Recall Bulletin

SUBJECT: Degraded Connection between Ignition Coil Spark Plug Boots and Spark Plugs

MODELS: 2009-2011 Chevrolet Aveo
2009-2010 Pontiac G3/Wave
Equipped with a 1.6L Gas Engine (LXV)

Subject: 11290C – Emission Recall
Degraded Connection between Ignition Coil Spark Plug Boots and
Spark Plugs
Revised Service Procedure

3459357

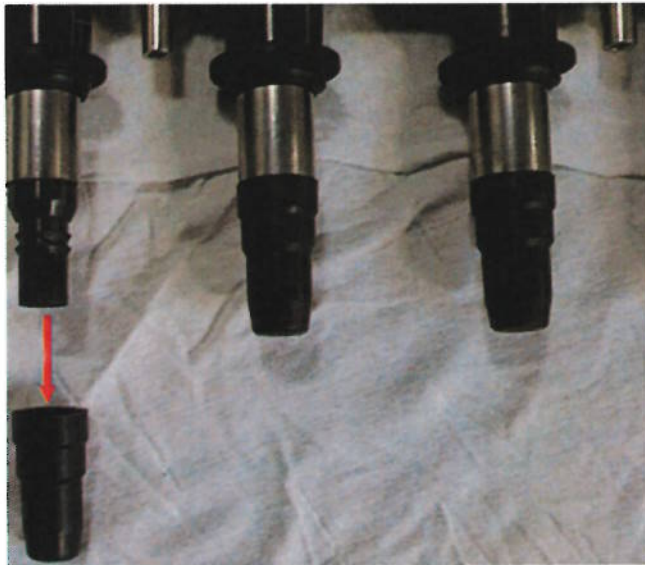
The Service Procedure section in this bulletin has been revised to include instruction on how to remove the coil boot with compressed air. Please discard all copies of bulletin 11290B.

Caution: To avoid part damage, remove boots with coils in the horizontal position. Install new springs and boots with coils pointing up to ensure the spring stays in the coil and is centered. The new boot is fully seated when it is within 1 mm (0.040 inch) of metal shield.

3459359

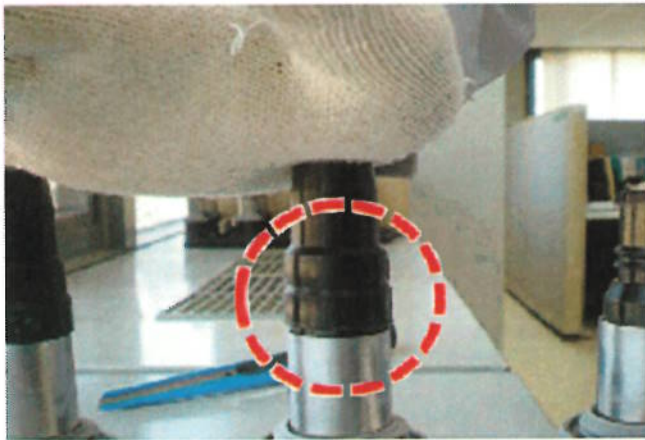
5. Insert compressed air nozzle (1) into the boot. Ensure the air nozzle is inserted in the boot enough to form a tight seal between the air nozzle and boot.

6. Push the air nozzle button to inject compressed air into the boot. Inject compressed air into the boot until the boot is removed from the metal shield. Perform steps 5 and 6 on the remaining three boots BEFORE proceeding to step 7.
7. Insert the new boots onto the ignition coil towers partially.
